August 10, 1981
LIL 216

Three Mile Island Nuclear Station, Unit 1 (TMI-1)
Operating License No. DPR-50
Docket No. 50-289
Status Report Plant Shielding Restart Report
Section 2.1.2.3, Table 2.1-9

ATTACHMENT

Figure 2.1-12.

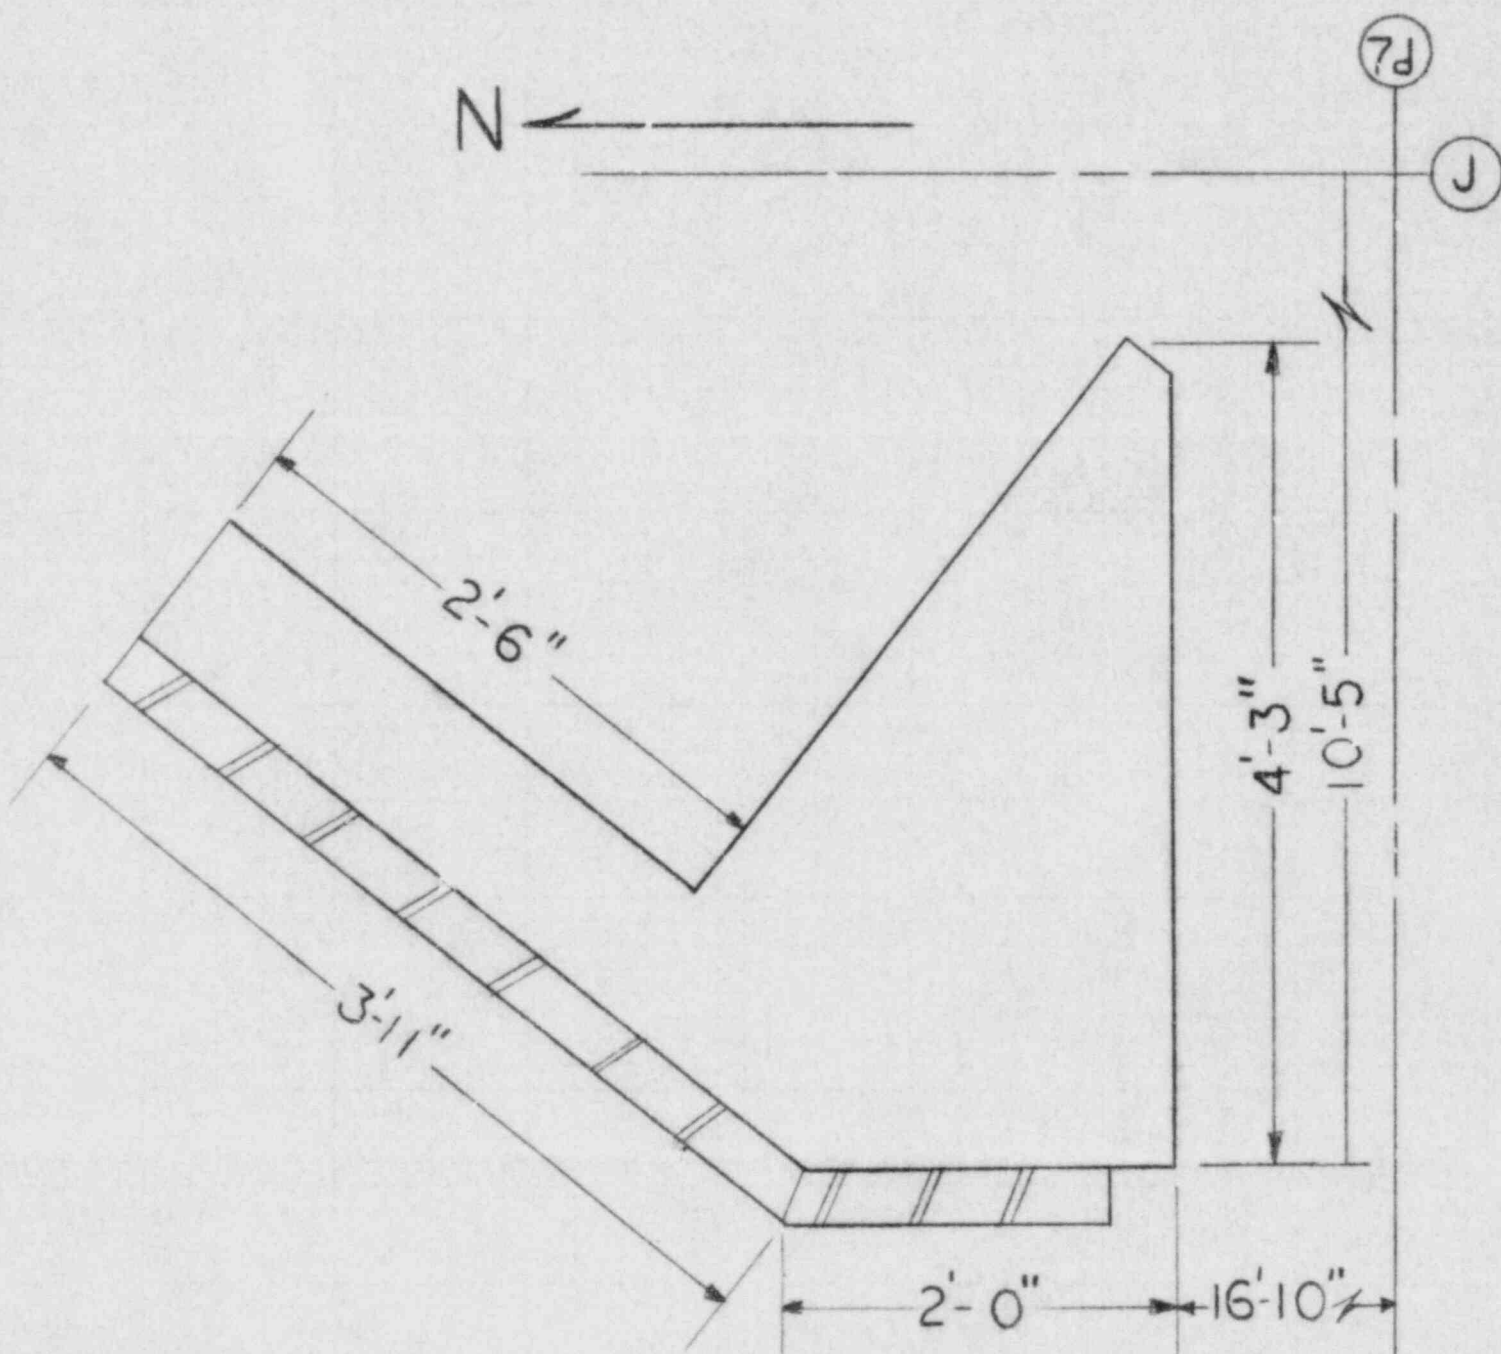
2. Install a shield wall in Area IV, to isolate the MCC's from the piping	<p>A reinforced concrete shield wall has been designed and will be in place prior to Unit 1 Restart. The wall starts at column line 7d, encloses the stairwell in Area III of Figure 2.1-12, continues parallel to column line J and terminates about 9 feet from the containment wall. Shield wall height is 12'-4". Access aisles are maintained between the shield wall and the piping along column line J, MCC 1A & 1B and the containment outer wall. Wall sections in the North-South direction are 13 inches thick for direct radiation shine attenuation and are interconnected by a 9 inch thick East-West section.</p> <p>The shield wall reduces the radiation dose rate in Area III to permit operator access post accident to reset circuit breakers in MCC 1A and/or 1B.</p> <p>The reactor coolant pump seal water supply line and high pressure injection line B bridge the access aisle between the shield wall the containment outer wall. These lines are shielded by a 3 1/2" thick steel plate assembly at elevation 313'-0". The plan view of the shield plate assembly is shown in Figure 2.1-12a attached. The entire plate assembly is removeable for maintenance access to valve operators in other overhead piping.</p>

4. Change valves DH-V12A & B to electric motor operated. Operate DH-V64 via reach rod extension on Aux. Building 305' elevation. Extension stem is located so that operator is protected by above noted shield wall.

A remote manual floor stand operator for DH-V64 is located in Area IV on elevation 305', reference figure 2.1-12.

The calculated radiation dose rate in Area IV permits operator travel and a 5 minute stay time for valve operation no earlier than 11 hours after a LOCA. The total accumulated dose rate for this operation is less than 3 rem.
